TLR/RES/DE/CIB-2020-13

**Technical Input for the U.S. Nuclear Regulatory Commission Review  
of the 2017 Edition of ASME Boiler and Pressure Vessel Code,  
Section III, Division 5, “High-Temperature Reactors”**

**HBB-T, HBB-II, HCB-I, HCB-II, and HCB-III for Metallic Components**

December 2020

**Figure A-25 Comparison of calculated code isochronous curves for Alloy 800H at 750 degrees C (1382 degrees F) to data from the NIMS database.**

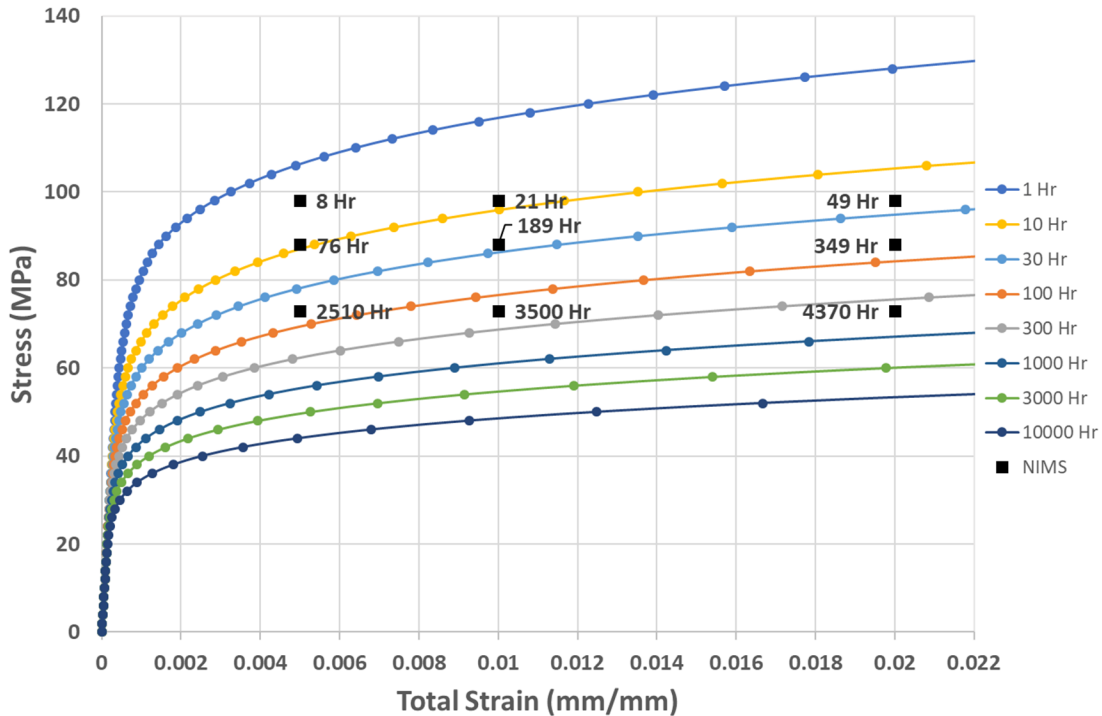
Figure A-25 compares NIMS data to the isochronous curves at 750 degrees C (1382 degrees F), which is near the maximum temperature permitted (760 degrees C) (1400 degrees F). All of the isochronous curves at this temperature are conservative. However, the time in the NIMS data only goes up to 4,370 hours maximum.

**Figure B-1 Comparison of creep-fatigue test data with code design rule predictions (316 SS)**

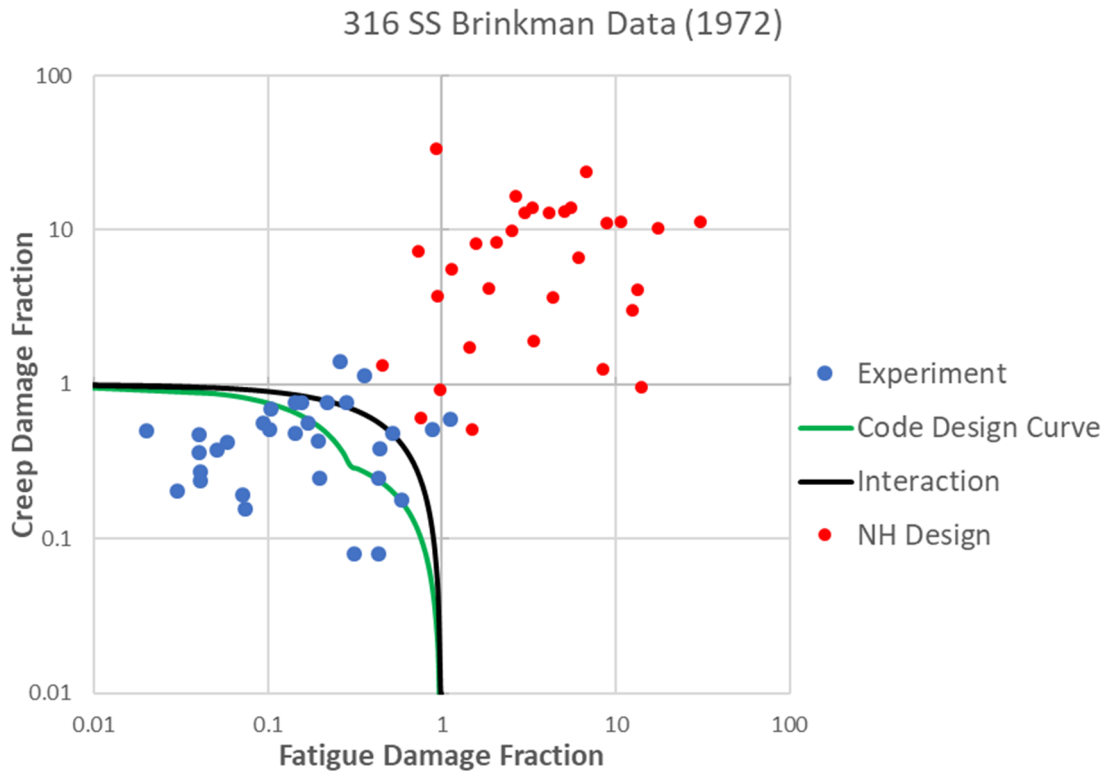
Figure B-1 illustrates the data developed by Brinkman for 316 stainless steel (SS). The black curve represents the linear creep-fatigue damage rule with no interaction diagram safety factor. The green curve represents the BPVC-III-5 interaction rule, with vertex at (0.3, 0.3) for stainless steel. Note that these data are plotted on log-log scale so all the data can be seen. These tests were performed using a variety of load-hold creep-fatigue conditions and for irradiated test specimens as well. The blue data dots represent raw test data from Brinkman et al. (1972) (note that this is not all the data—especially for cases dominated by creep or fatigue failure). The data inside the curve represent nonconservative results compared to the interaction diagram. The first observation is that the test data points do not add up to one (i.e., the black curve). Moreover, much of the raw data (blue curves) are also inside the code interaction curve (green curve) showing that the raw data are nonconservative for most of the data points based on code rules. The red data points represent the data with the code rules applied.<sup>1</sup> All of the red data points are outside the code interaction diagram, which shows conservatism. The conservatism is significant for many of the data points (being greater than 25 in many cases as seen in Figure B-1).
